Allowance Expense Authorization and Change Order #1
Wellness Center Parking Lot & ADA Requirements at Administration

FALLBROOK HEALTH

ADMINISTRATIVE OFFICE

WELLNESS CENTER

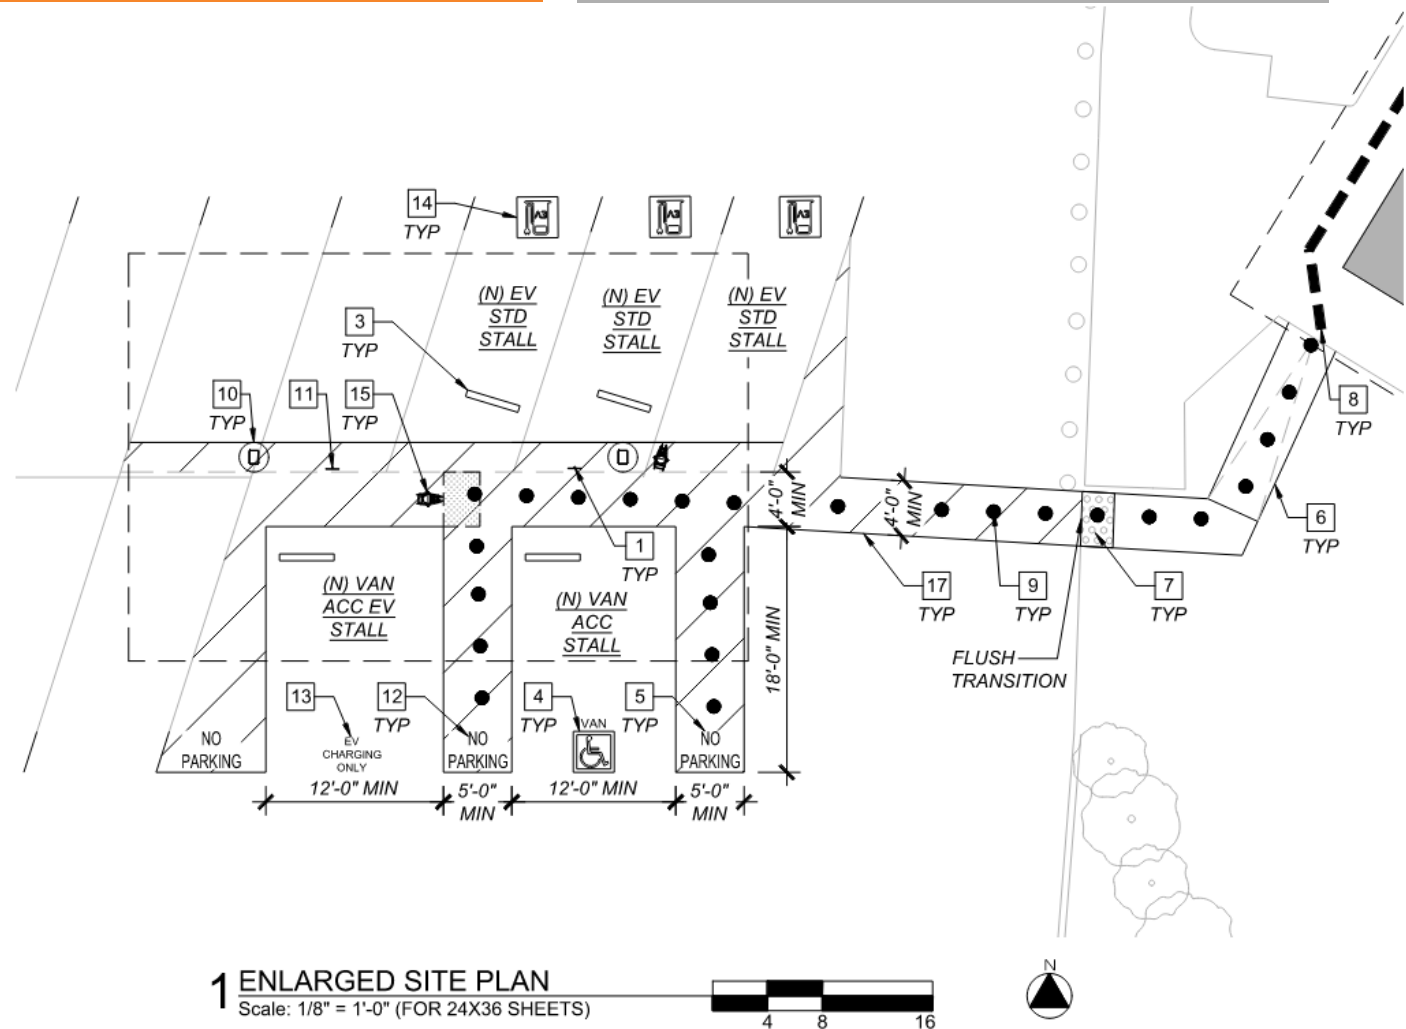
Requirements:

1. (1) covered accessible stall and (1) accessible van EV stall.
2. The existing non-covered ADA stall at the SW corner of lot, remains.
3. Adding (3) new standard EV stalls.
4. Grade and pave accessible parking stall and accessible path of travel, per approved architectural plans.
5. Restripe using (1) coat of water-based, state-approved paint.

1 ENLARGED SITE PLAN

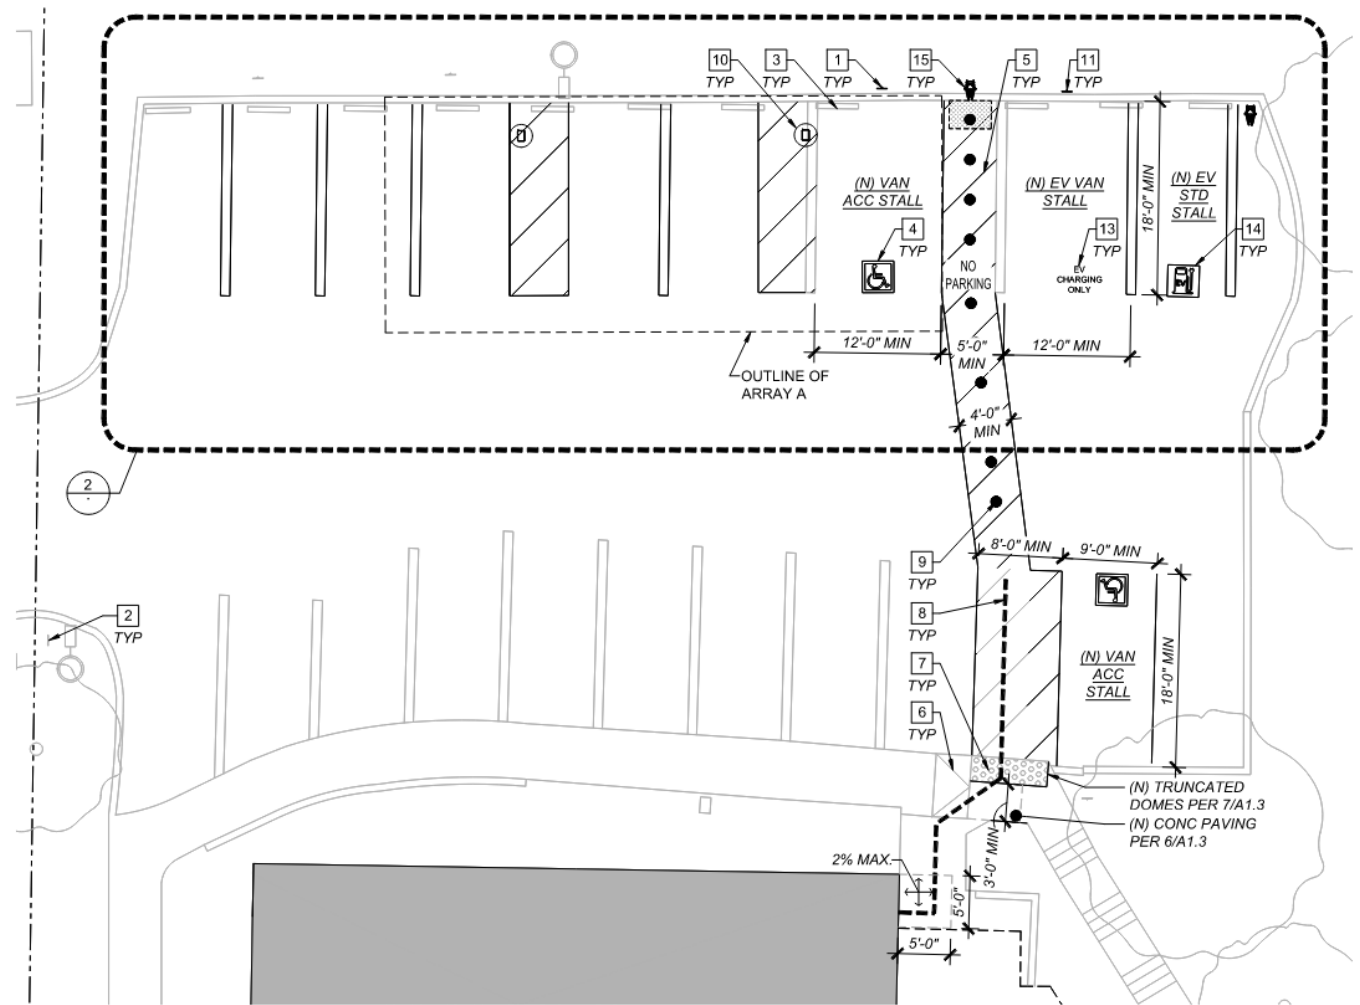
Path of travel: Required to be less than 5% slope in direction of travel and less than 2% cross-slope.

Accessible stalls: Required to be less than 2% slope in all directions.

1. (1) covered accessible stall and (1) accessible van EV stall.
2. Adding (1) standard EV stall.
3. Columns are required to be 10' min away from the property line.
4. Curb ramp needs to be leveled, and the rock feature would need to be demolished for compliant path of travel.
5. Restripe using (1) coat of water-based, state-approved paint.

* Existing ADA stall next to the entrance, exceeds the maximum slope requirements, and does not have the required 8' access aisle

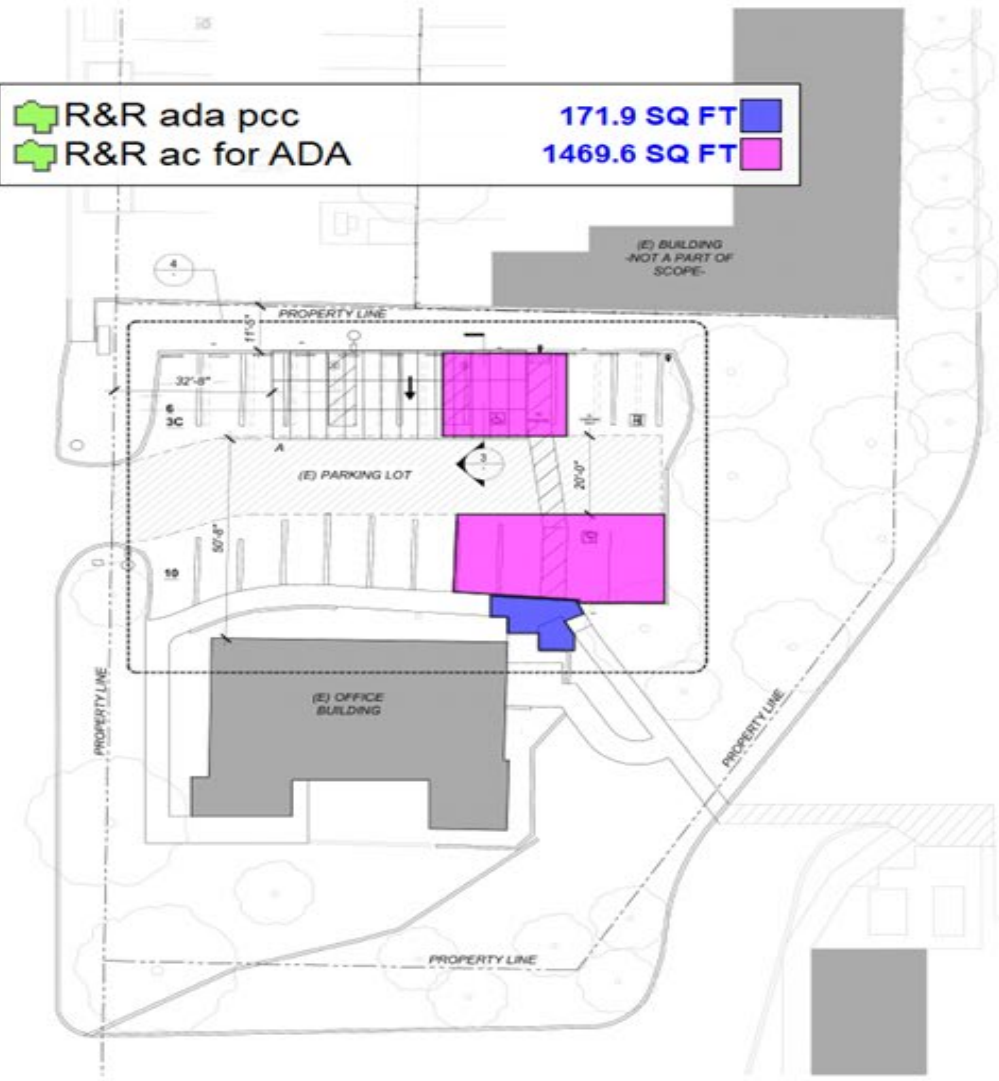
R&R ada pcc 171.9 SQ FT 
 R&R ac for ADA 1469.6 SQ FT

- BOTH (E) AND (N) POT REQUIRE:
5% DIRECTIONAL SLOPE MAX.
2% CROSS SLOPE MAXIMUM
- STALLS AND ACCESS AISLES REQUIRE:
2% DIRECTIONAL SLOPE
2% CROSS SLOPE MAX
- FOR STRIPING, COLOR, WHEEL STOP, AND ALL OTHER DIMENSIONS, REFER TO SHEET A1.2
